## GIRDWOOD TRAILS PLAN

### Public Review Draft – Recommendations for Changes/Edits

RE: GTP Public Review Draft

Recommended Changes

**NS1: Virgin Creek Natural Space**

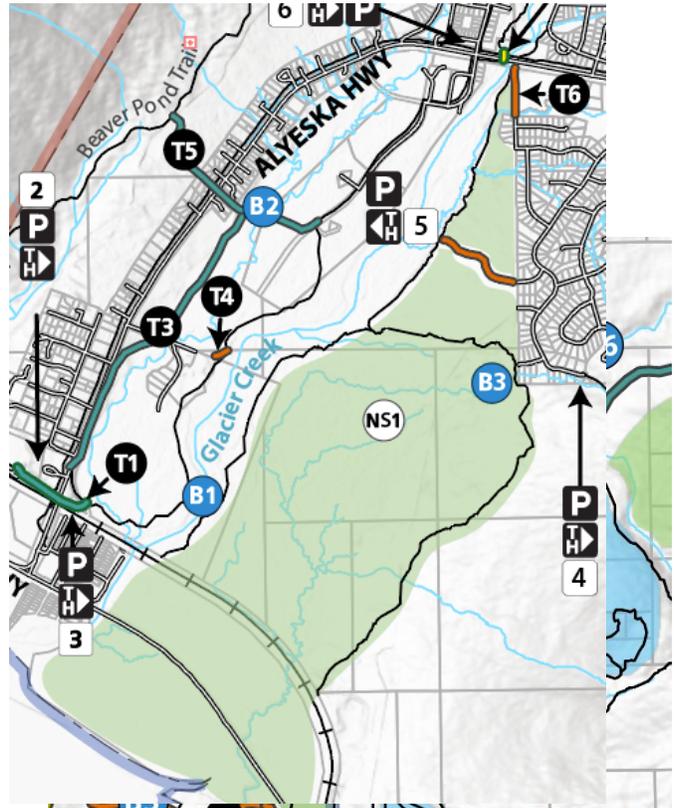
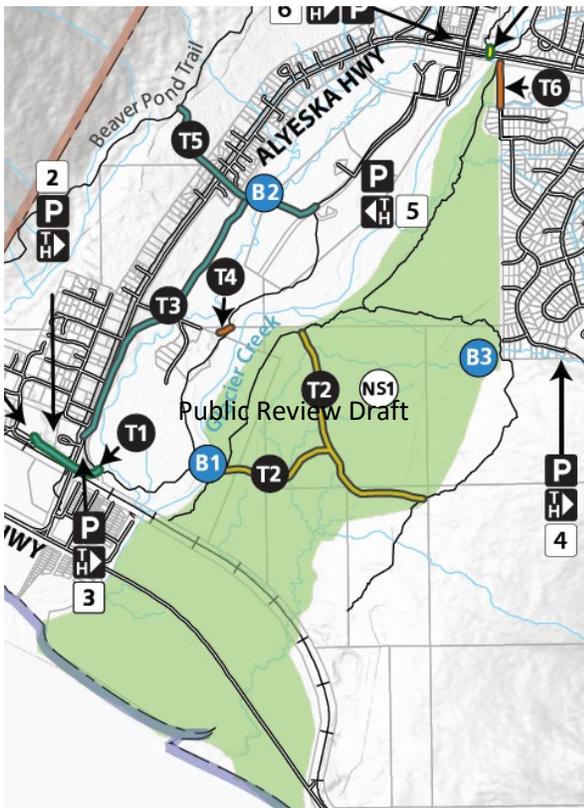
Recommend adjusting the boundary of NS1. The eastern boundary should extend and include the Wagon Trail. The western boundary should be adjusted to remove the Joe Danich Trail from NS1. ADD a trail project to the plan that brings the Joe Danich up to a Class 3 trail constructed to the bicycle design parameter and relocate out of wetlands to uplands. ADD trail project to the plan to construct neighborhood connector trail (Class 3, bicycle design parameters, constructed in uplands) from the Turin and/or Carlina Drive cul-de-sacs to connect to the Joe Danich trail. NS1, with the adjusted boundary, remains non-mechanized with trails that are no greater than Class 2. Comments indicate that residents want a multi-use alternative trail to connect from the lower valley to the upper valley without using the road system. A Class 3 designation provides a sustainable connection to neighborhoods. The eastern boundary shift better aligns with a primitive experience for the Wagon Trail.

**NS2: Stumpy's Natural Space**

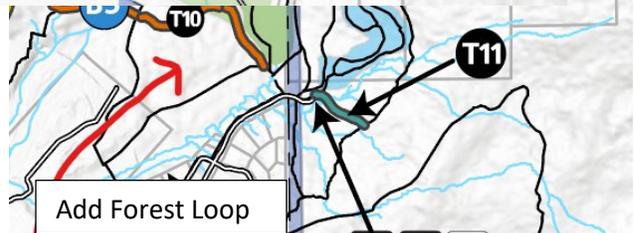
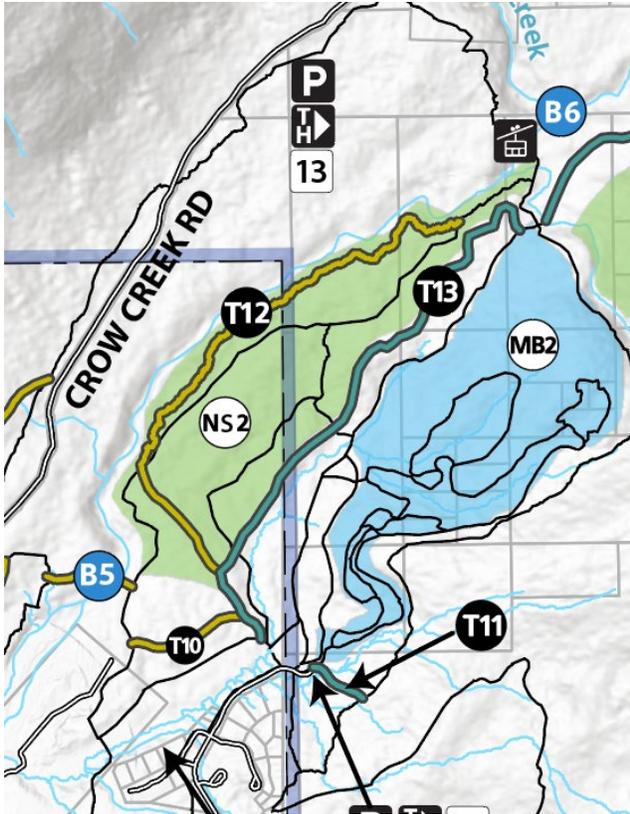
Recommend adjusting the boundary of NS2. Expand the boundary to the east to extend up to but not including the Snowcat Trail and the groomed section of Stumpy's winter trail. (T13-Upper Valley Multi-Use Trail recommended to be removed from the draft plan and add Forest Loop back).

**MB1: Beaver Pond MB Area**

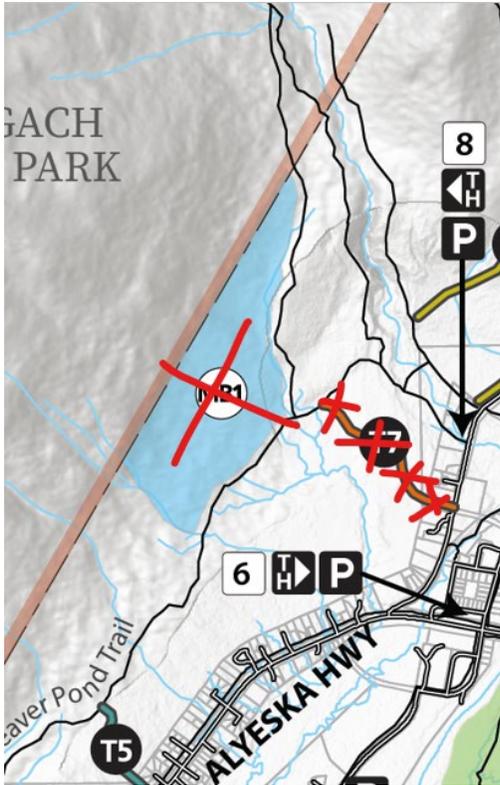
***CHANGE RECOMMENDED – Remove MB1 from the plan:***

There is not consensus about this project. Needs more discussion – if included in the plan MB1 shall be developed in consultation with the Girdwood Trails Committee only after MB2 is complete. If MB1 is removed, user conflicts on Abe's and California Creek Trails still need to be addressed.

KEEP MB1 in the PLAN

### **TH 3**

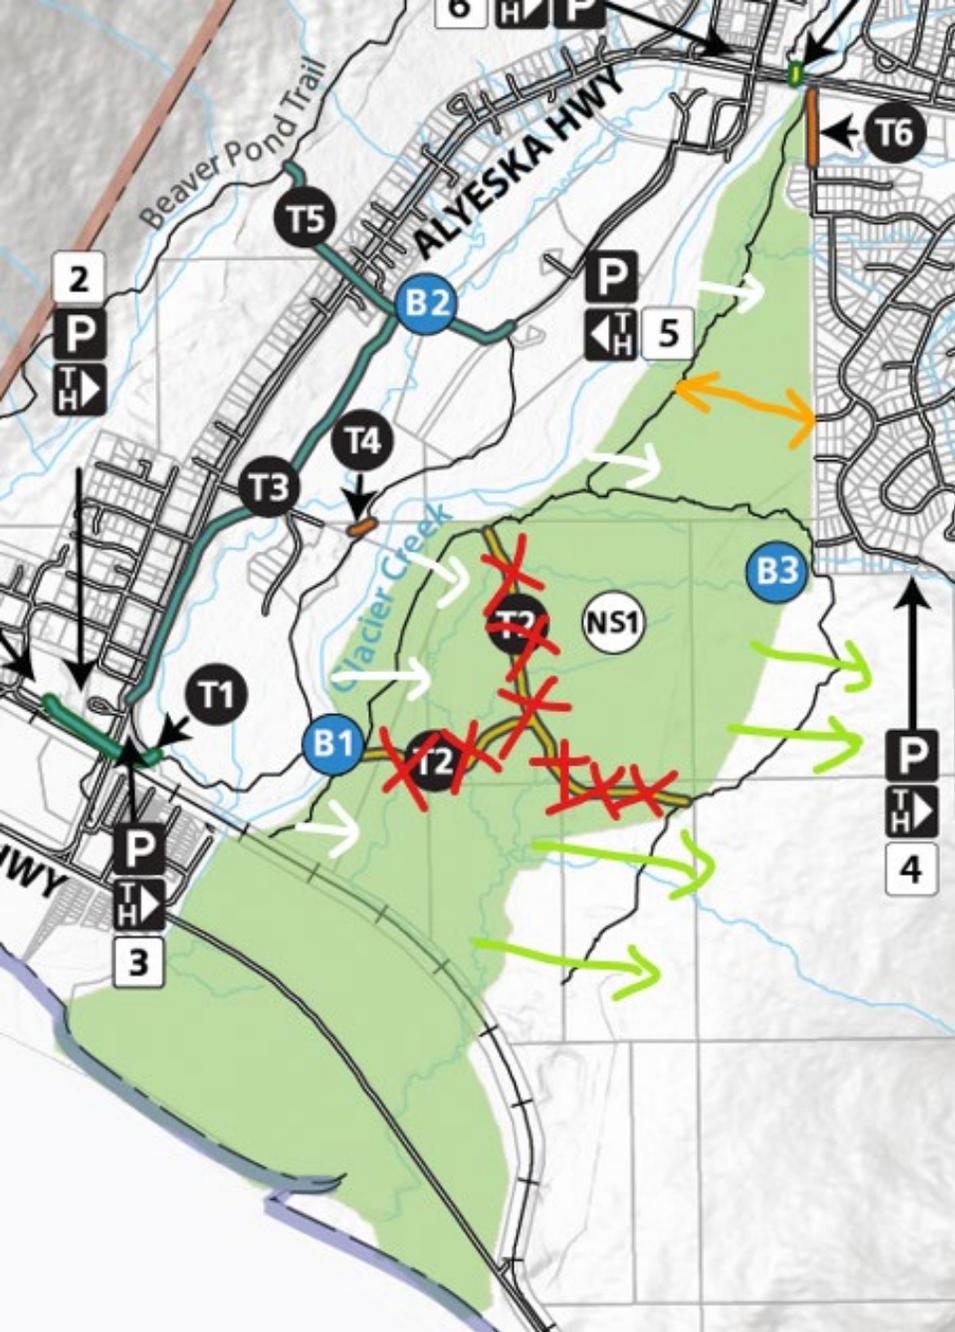
**CHANGE RECOMMENDED** – Remove this trailhead from the plan.

**WHY:** Comments indicated there was not public support for this trailhead.

## NS1: Virgin Creek Natural Space

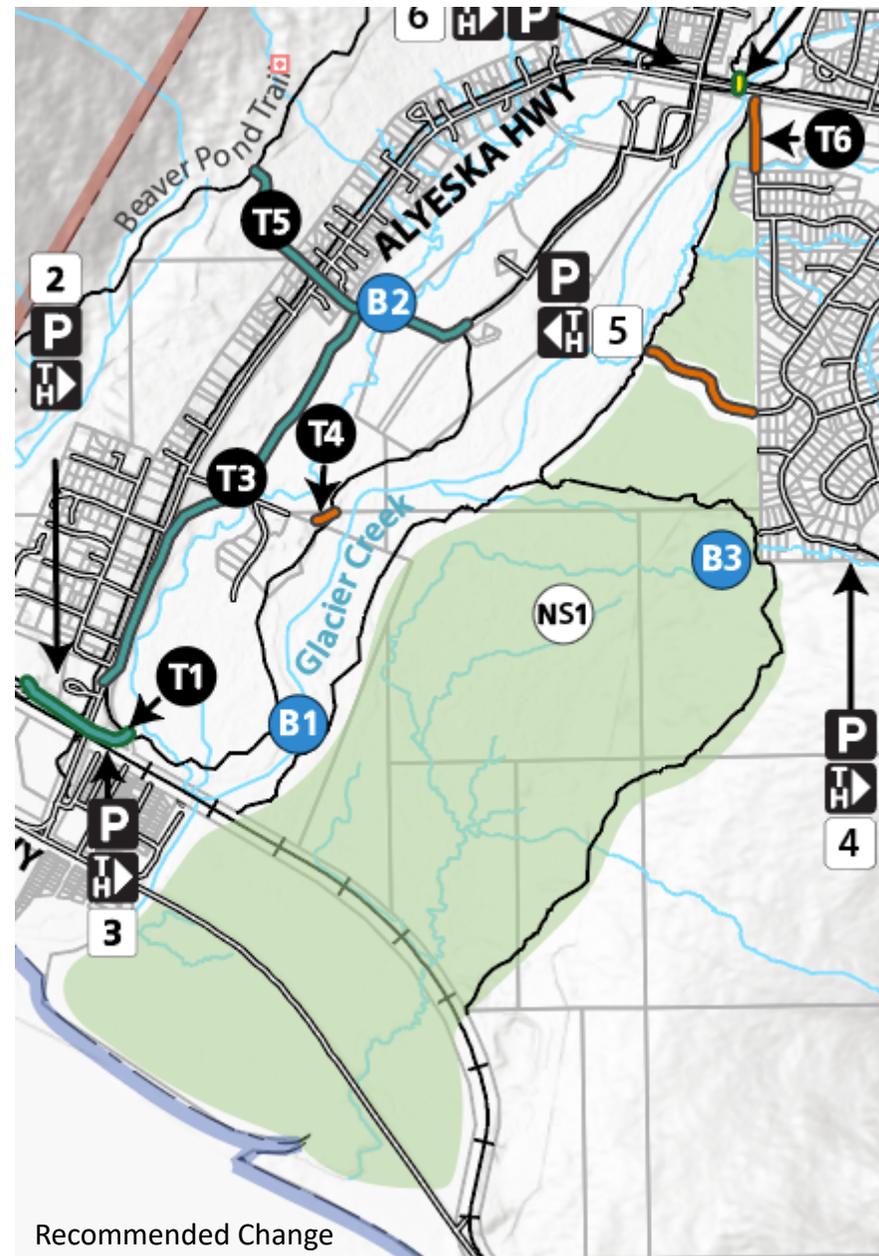
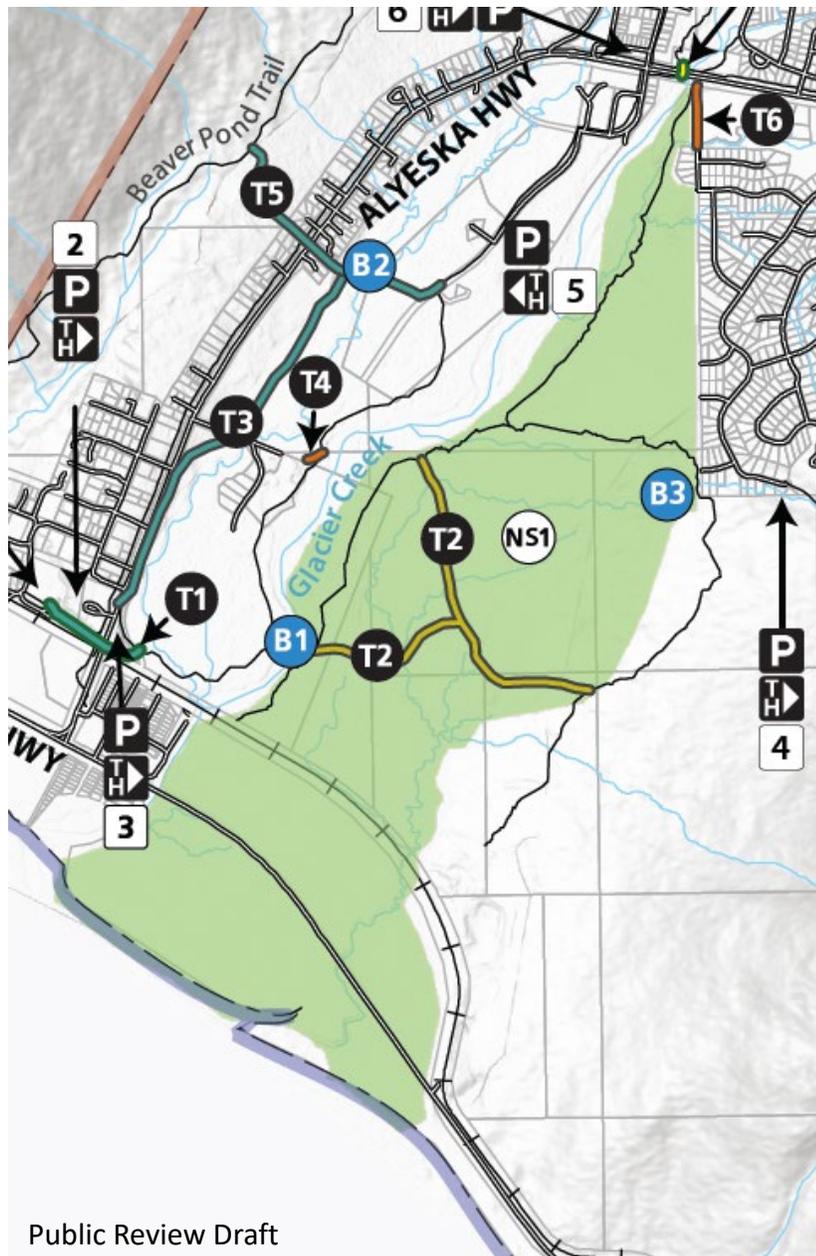
Recommend adjusting the boundary of NS1. The eastern boundary should extend and include the Wagon Trail. The western boundary should be adjusted to remove the Joe Danich Trail from NS1. ADD a trail project to the plan that brings the Joe Danich up to a Class 3 trail constructed to the bicycle design parameter and relocate out of wetlands to uplands. ADD trail project to the plan to construct neighborhood connector trail (Class 3, bicycle design parameters, constructed in uplands) from the Turin and/or Carlina Drive cul-de-sacs to connect to the Joe Danich trail. NS1, with the adjusted boundary, remains non-mechanized with trails that are no greater than Class 2. **WHY:** Comments indicate that residents want a multi-use alternative trail to connect from the lower valley to the upper valley without using the road system. A Class 3 designation provides a sustainable connection to neighborhoods. The eastern boundary shift better aligns with a primitive experience for the Wagon Trail.

### MB1: Beaver Pond MB Area

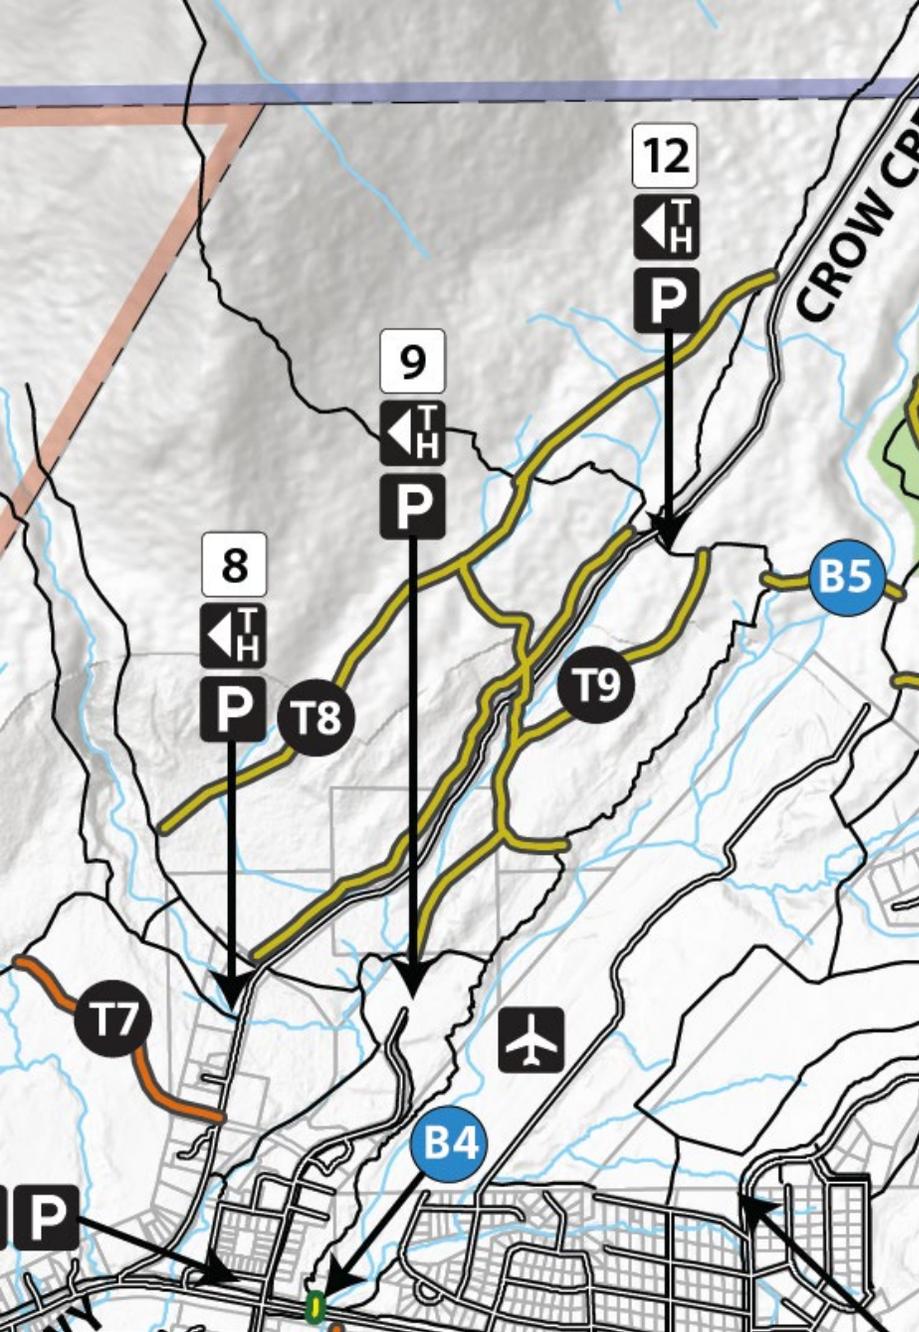
Recommend removing MB1 from the plan. **WHY:** There is not consensus about this project. Needs more discussion – if included in the plan MB1 shall be developed in consultation with the Girdwood Trails Committee only after MB2 is complete. If MB1 is removed, user conflicts on Abe’s and California Creek Trails still needs to be addressed.

### **NS2: Stumpy’s Natural Space**

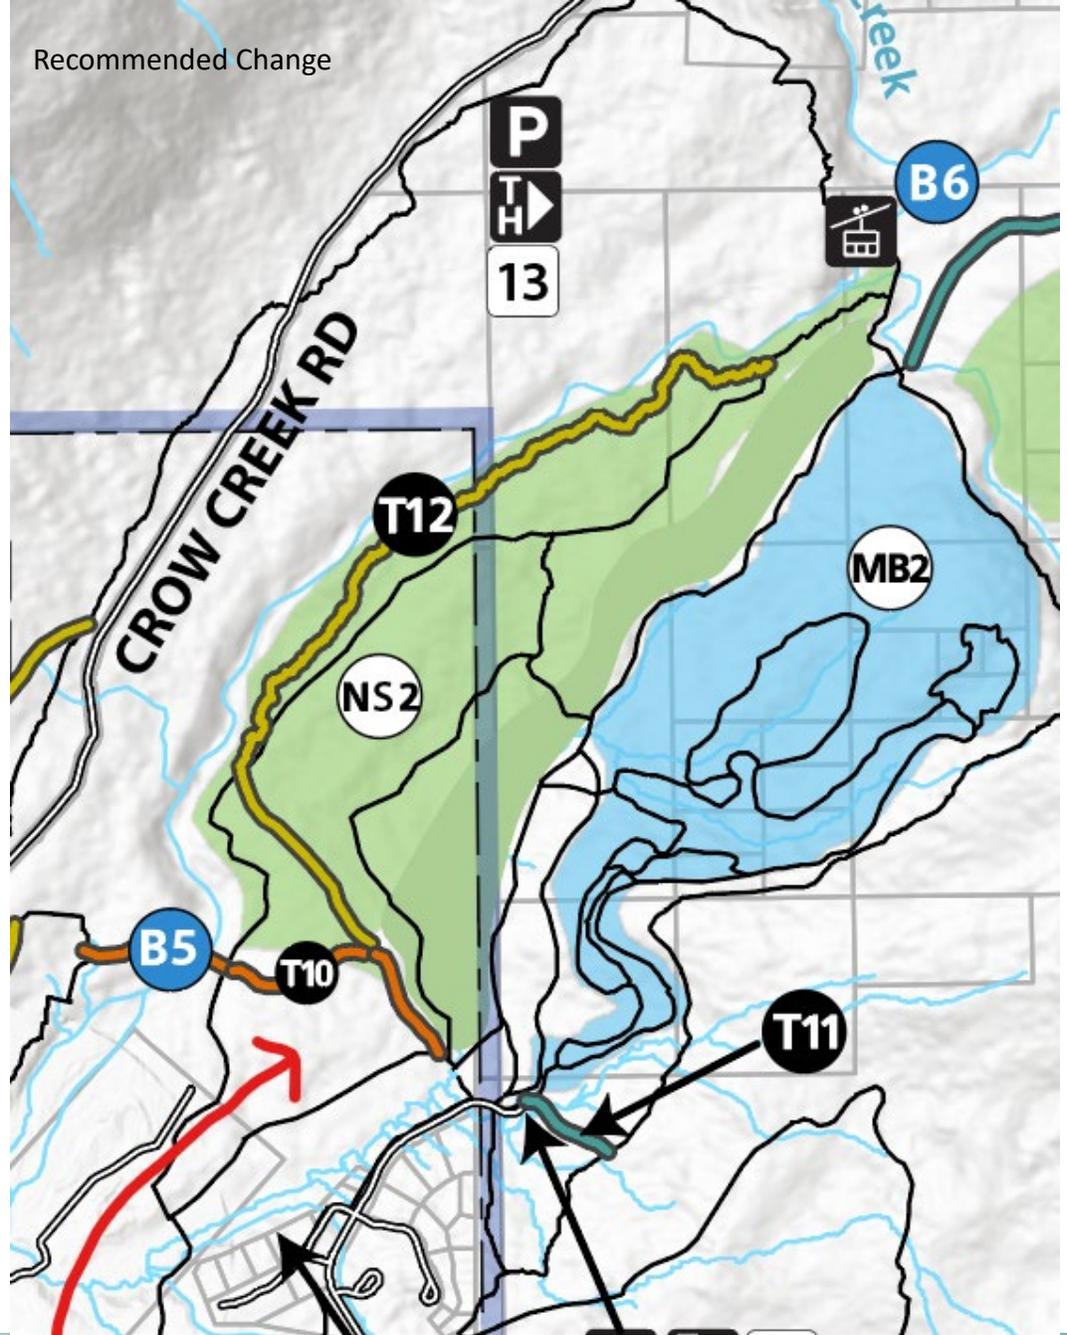
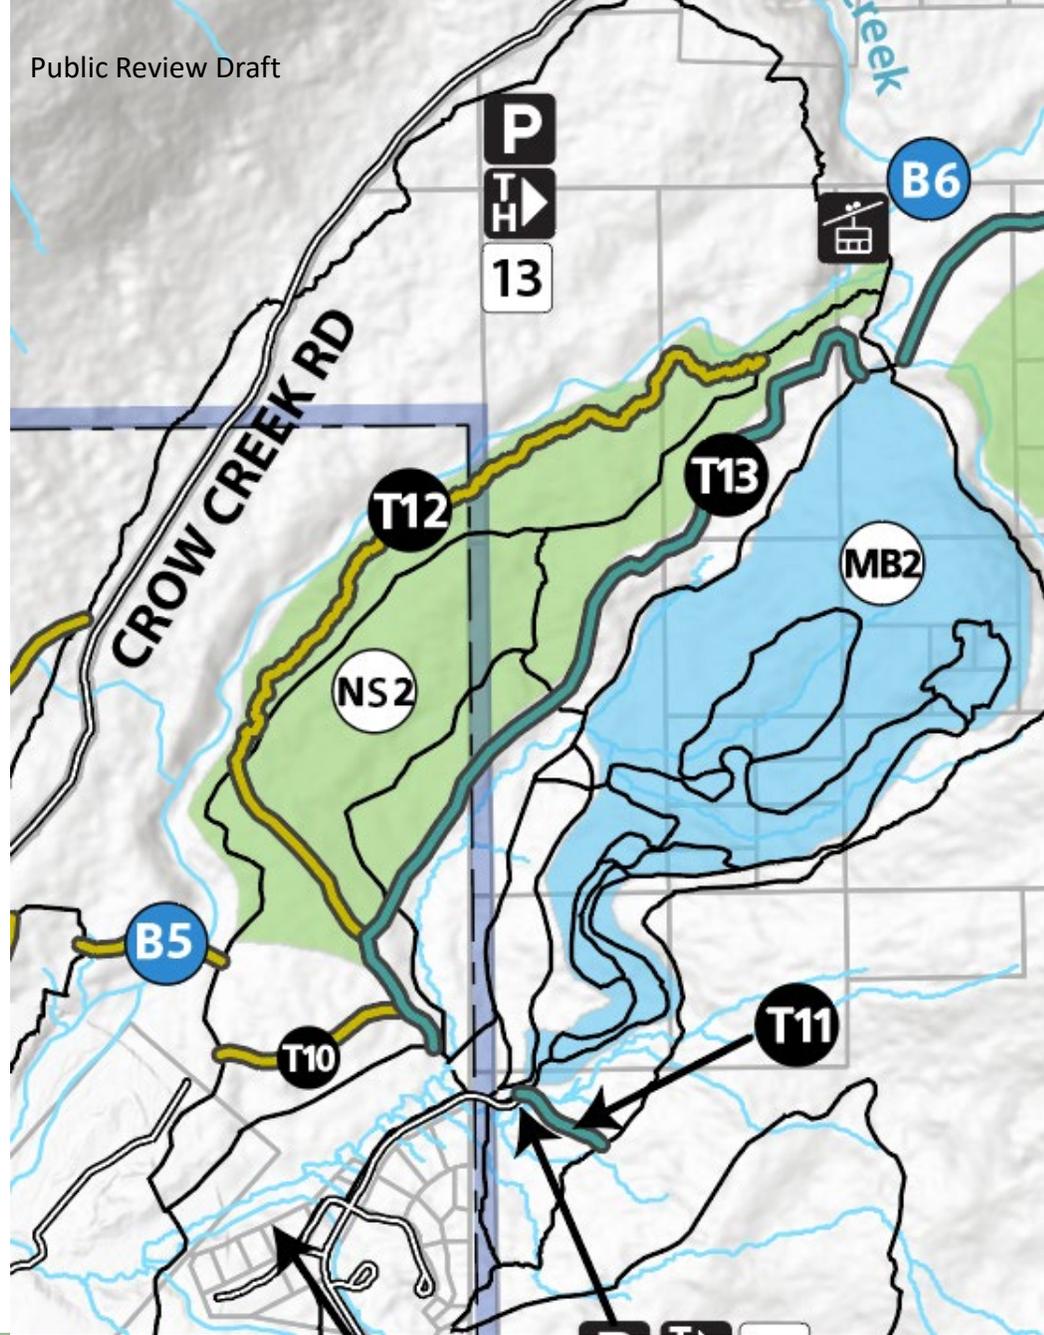
Recommend adjusting the boundary of NS2. Expand the boundary to the east to extend up to but not including the Snowcat Trail and the groomed section of Stumpy’s winter trail. **WHY:** There isn’t consensus for T13 and the wetlands are better suited for a more primitive experience.
